Access Compliance Report

Public Rights-of-Way (Curb Ramps)

Intersection ID: 27595	Main Street: BALLANTYNE COMMONS PY	Cross Street: BALLANTYNE MEADOWS DR	Location: NE
ADA ID: 416E348E346D	Ramp Type: Perp	Initial Pass/Fail: Fail	Overall Compliance: No
Codes/Mitigation Info/Possible Solution			Severity Score: 10
			Field Measurements/Component Compliance

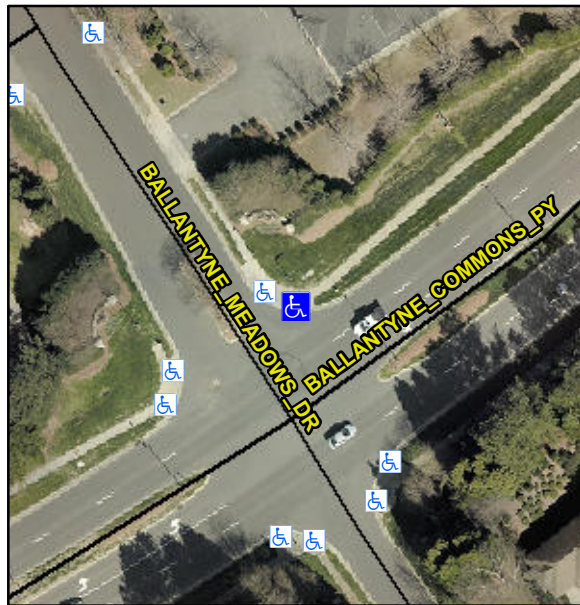
Not Found, R304.5.1

Compliance	Description	Data	Compliance	Description	Data
N/A	Ramp Length (in)	106.0	Yes	Ramp Slope (%)	6.5
No	Ramp Width (in)	38.0	Yes	Ramp XSlope (%)	2.9
N/A	Flare Type LT	N/A	N/A	Flare Type RT	N/A
N/A	Flare Slope LT (%)	N/A	N/A	Flare Slope RT (%)	N/A
N/A	Flare Traversable LT?	N/A	N/A	Flare Traversable RT?	N/A
N/A	Landing Length (in)	N/A	N/A	DWS Provided?	N/A
N/A	Landing Width (in)	N/A	N/A	DWS Contrast?	N/A
N/A	Landing Slope (%)	N/A	N/A	DWS Length (in)	N/A
N/A	Landing X Slope (%)	N/A	N/A	DWS Full Width?	N/A
N/A	Landing Curb? (Y/N)	N/A	N/A	DWS Offset (in)	N/A
N/A	Shared Landing?	N/A			
N/A	Gutter Ponding?	N/A	N/A	Gutter Slope (%)	N/A
N/A	Gutter Lip Ht (in)	N/A	N/A	Gutter X Slope (%)	N/A
N/A	Painted X Walk1?	No	N/A	Painted X Walk2?	N/A
	X Walk 1 Direction	To SE		X Walk 2 Direction	N/A
N/A	X Walk 1 Width (in)	N/A	N/A	X Walk 2 Width (in)	N/A
	X Walk 1 Slope (%)	3.3		X Walk 2 Slope (%)	N/A
	X Walk 1 X Slope (%)	5.1		X Walk 2 X Slope (%)	N/A

Remove & Replace Entire Ramp.
